**PUBLIC WORKS DEPARTMENT**

November 22, 2004

**Re: Revised Curb Ramp Details**

CalTrans has issued a memorandum dated October 7, 2004 regarding revised curb ramp details RSP A88A, A88B, A90A, and A90B. Copies of A88A and A88B are attached. These can also be downloaded at the following web site:

REVISED DUAL UNITS STANDARD PLAN RSP A88A

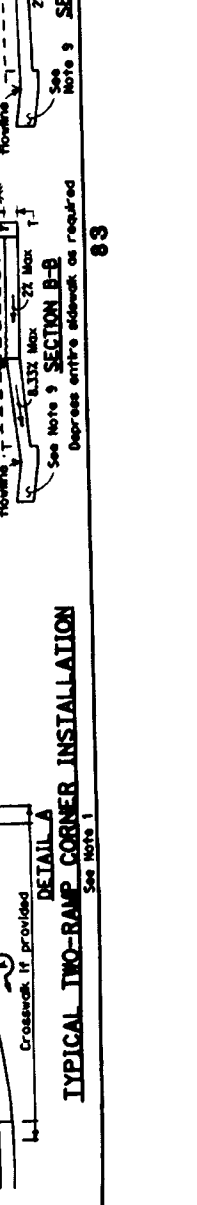
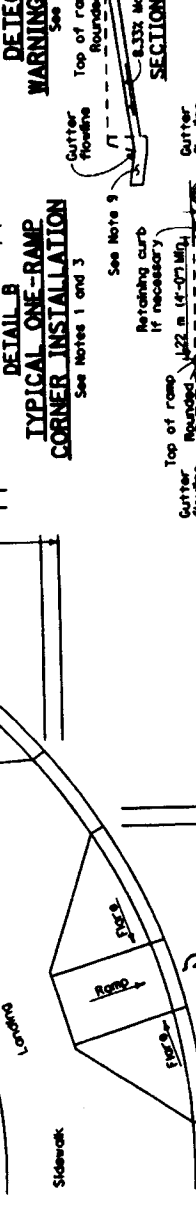
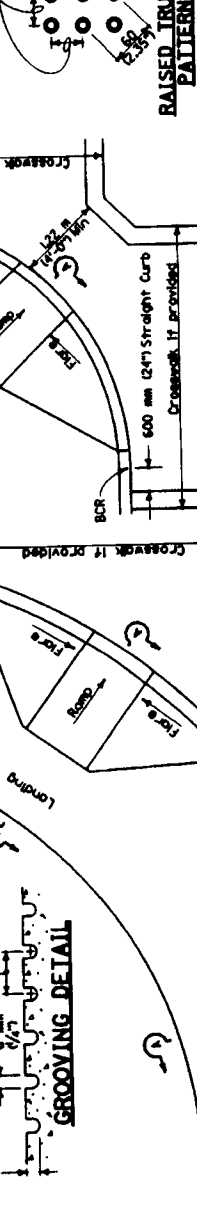
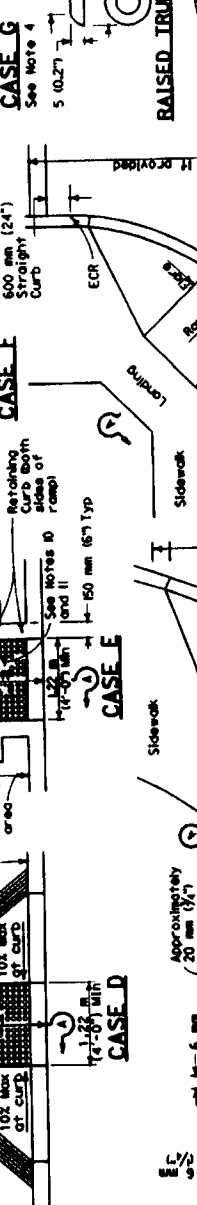
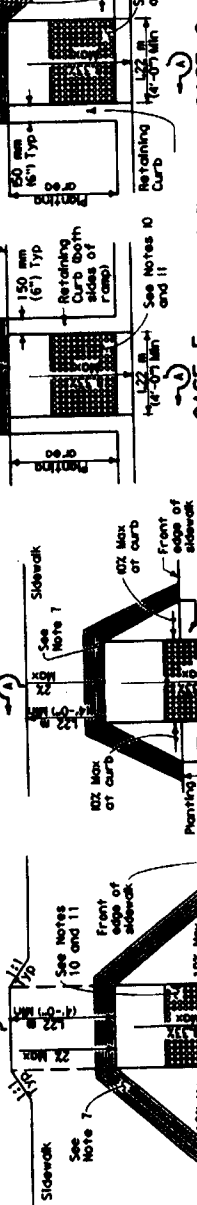
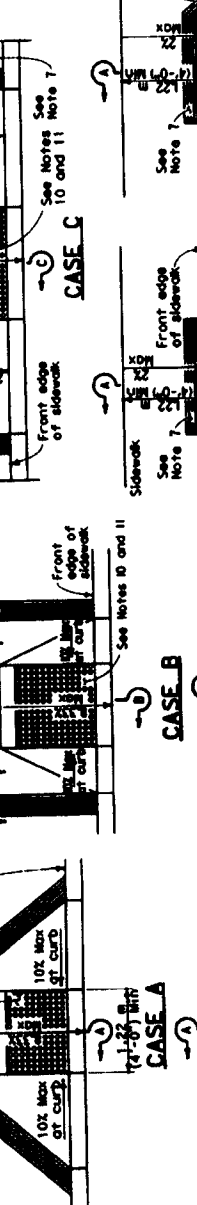
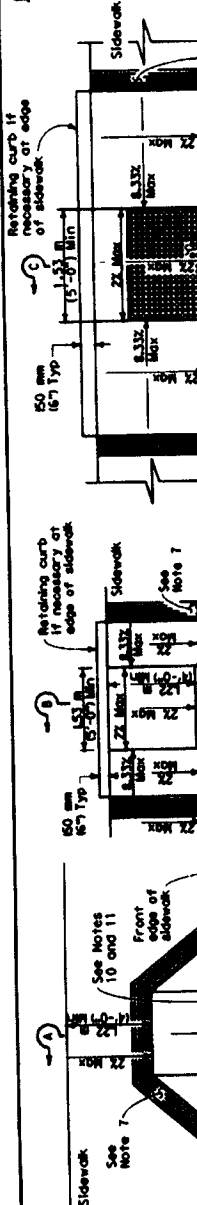
Both Federal and State laws require the revised standard for all public accessible ramps, not just for federally or state funded projects and highways. The most notable changes are the elimination of the ¼ inch lip at the bottom of the ramp (ramp to be flush with flowline), the replacement of a detectable warning surface for the herringbone pattern grooves, and the maximum flare slope reduction from 12.5% maximum to 10% maximum. Also note that the maximum slope of the gutter adjoining the ramp is 5%.

Effective immediately, all new curb ramps within the City's jurisdiction shall comply with the revised state standards. The City will issue a revised curb ramp "Subdivision and Engineering Design Manual" standard when complete.
